**From:** David Morris <David.Morris@darntonegs.com>
**Sent:** 22 July 2009 19:52
**To:** Carlos Hone
**Subject:** RE: ADC/0216/09 - replacement of existing Co-op signage with Asda Signage.
**Attachments:** 7288-20-02B_proposed_elevations[.pdf

**From:** Carlos Hone [mailto:Carlos.Hone@adur.gov.uk]
**Sent:** 01 July 2009 16:27
**To:** Kathleen Pointon
**Subject:** ADC/0216/09 - replacement of existing Co-op signage with Asda Signage.
Dear Ms Pointon,
RE: Replacement signage at Co-op Superstore South Street lancing.

**DRAWING**
PROPOSED ELEVATIONS

7288 [20] 02 B

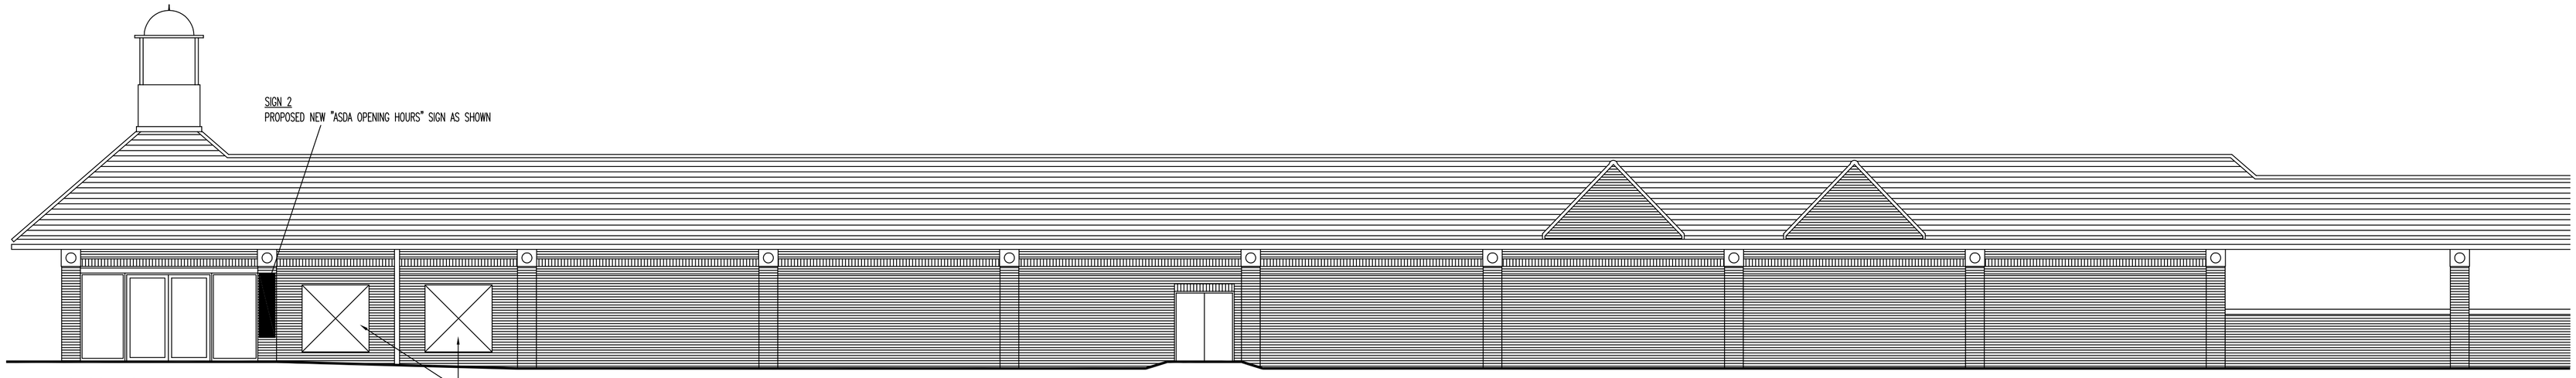
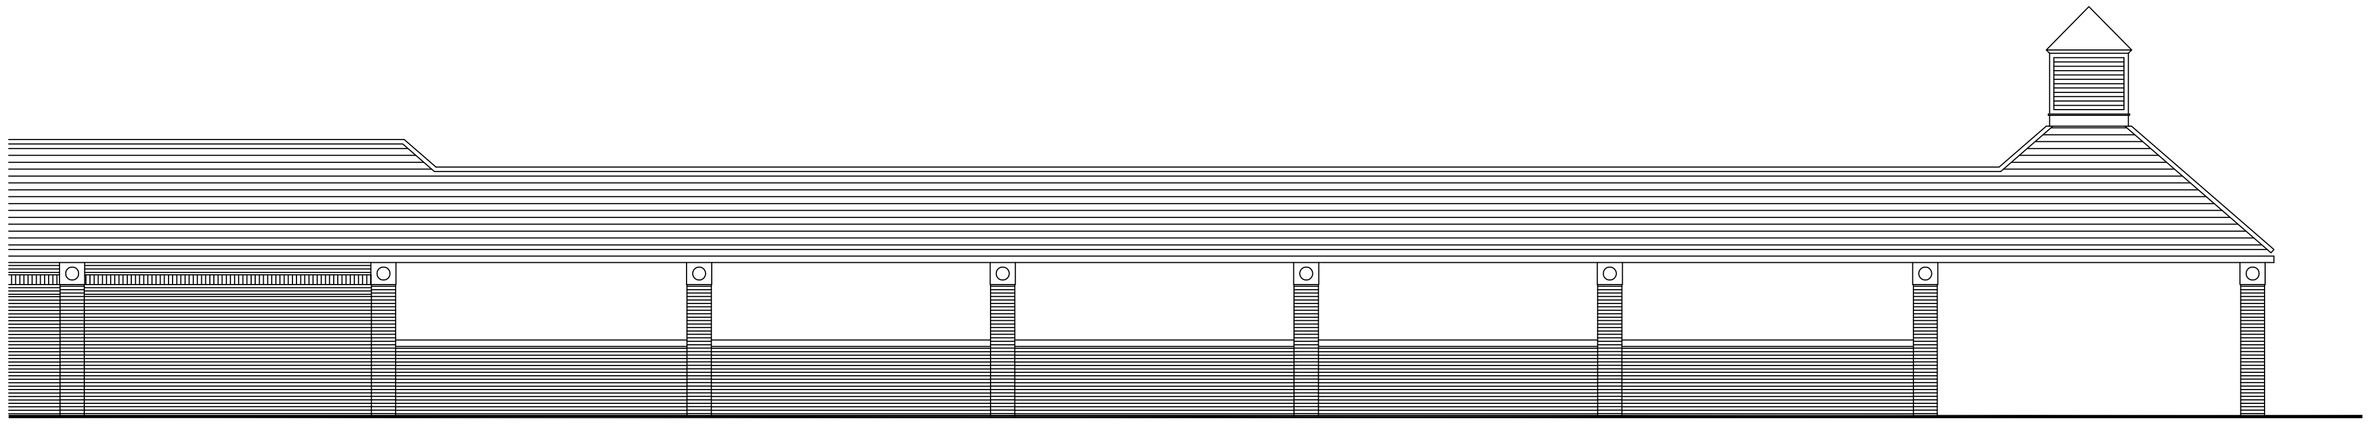
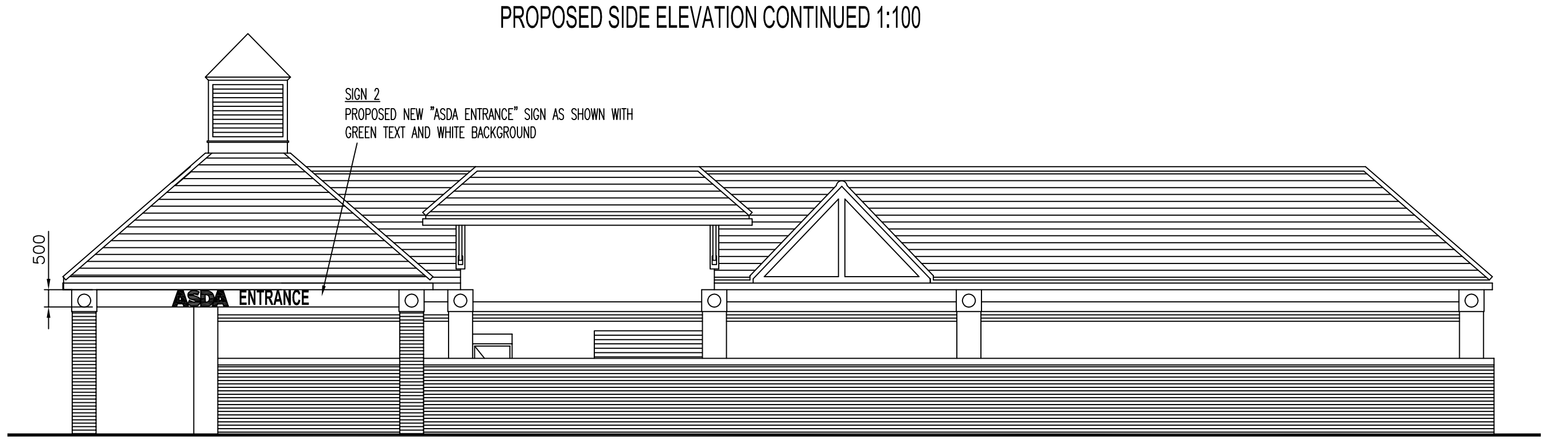
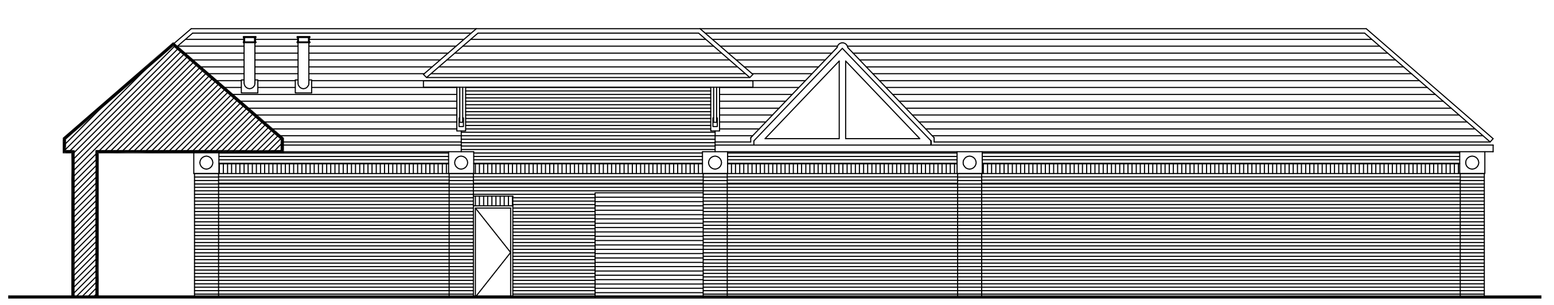
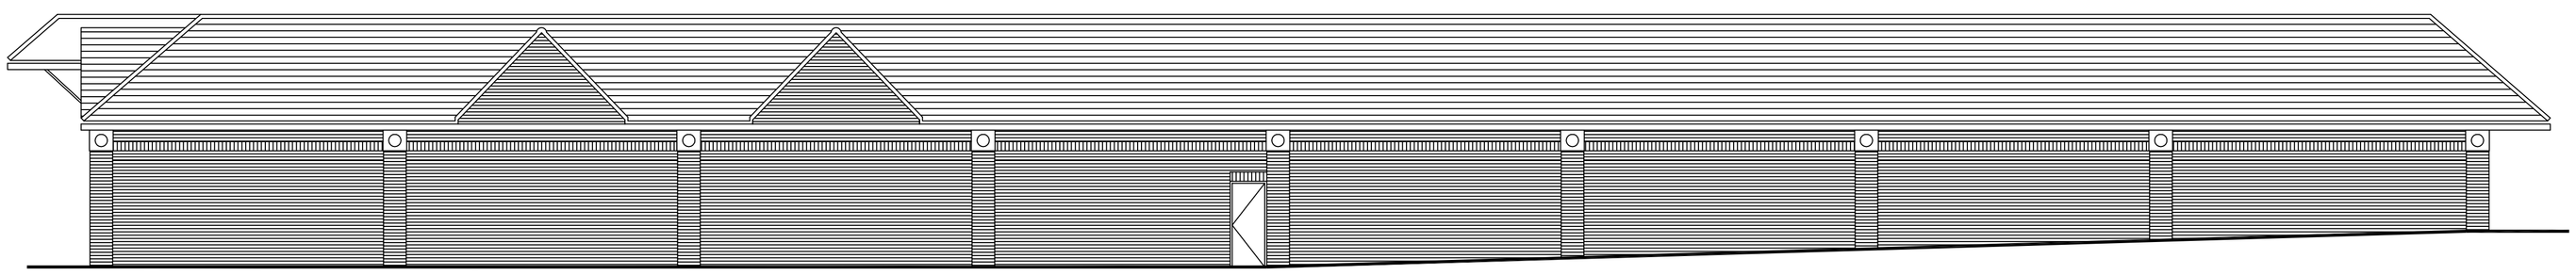
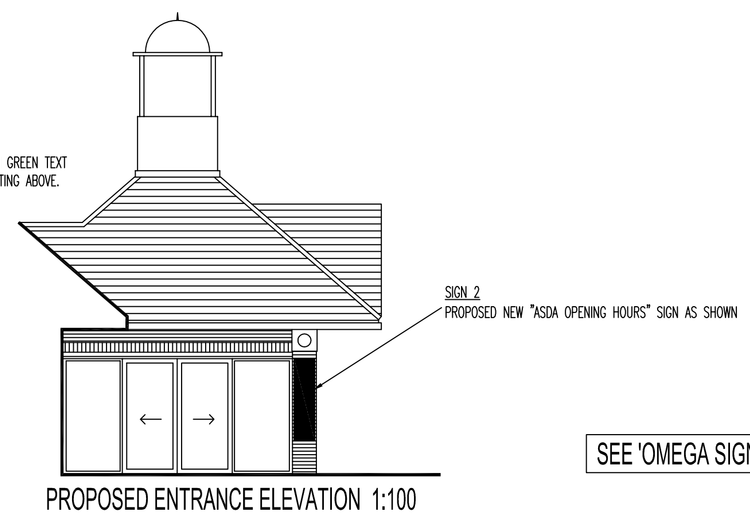
With regards to the amended plans submitted. The plans that you have submitted (16/07/09) still show the additional illuminated ASDA sign and temporary sign on the north elevation of the building.

Sign E1
Clarification of size of sign is needed.
As scaled off – 2.9m wide, by 4.6m in height, 1.25m off of the ground.
Or as written on application form 3.1m wide, by 5m in height, 1.4m off of the ground.
Also the means of illumination is stated as internal. Please clarify what parts of the sign will be illuminated and if any of it will be opaque. Also I would be grateful if you could let me know what will be on the reverse of the sign and whether any element will be illuminated.
Sign B
Clarification of size
As scaled it reads as 1.1m high, by 1.4m wide, by **1.9m** above ground
On application form 1.1m high, by 1.4m wide, 0.9m above ground. I assume this should read 1.9m
Sign J1 & G4
Clarification of size
Scaled off plan at 1:20 the signs are 0.4m in diameter, and 1.6m in total high (1.4m from ground).
As written on the application form 2m off ground and 0.64m in diameter.
Will G4 be illuminated?
So please can you clarify either by annotating drawing No.7288 (SG) 01 with the actual dimensions or writing to me with the actual proposed sizes of the signs, and other points raised above.

Having visited the site the existing sign in the front of the site for Co-op (yr sign E1) is approximately 1m wide by 4m in height, the smaller scaled off version of your proposed replacement is much larger than this and I have to say that I feel it will be too prominent at 2.9m wide by 4.6m in height (or even as written in yr forms 3.1m wide, by 5m in height). It is my opinion that the proposed replacement should not be so large, and that a reduction should be made. I would say to the same height as the existing sign and no wider than 1.5m.
I would be grateful if you could mention my comments to your client and if you propose to amend the scheme please forward to me three copies of the amended plans no later than 15 July 2009, if by which time none have been received the application will be determined on the basis of the current submission.
Yours sincerely
Carlos Hone
Planning Officer.

Further to our telephone conversation we have attached a pdf file of the elevations with the ASDA sign to the north elevation and temporary signage removed.

| REV | NOTE | DR | CH | DATE |
|---|---|---|---|---|
| B | ASDA SIGN TO N ELEVATION & TEMP SIGN REMOVED. | | | 22.07.09 |
| A | SIGNAGE PROPOSALS AMENDED TO SUIT LATEST OMEGA SIGNAGE DWG REV 4. TEMPORARY SIGNAGE ZONES SHOWN | | | 15.07.09 |
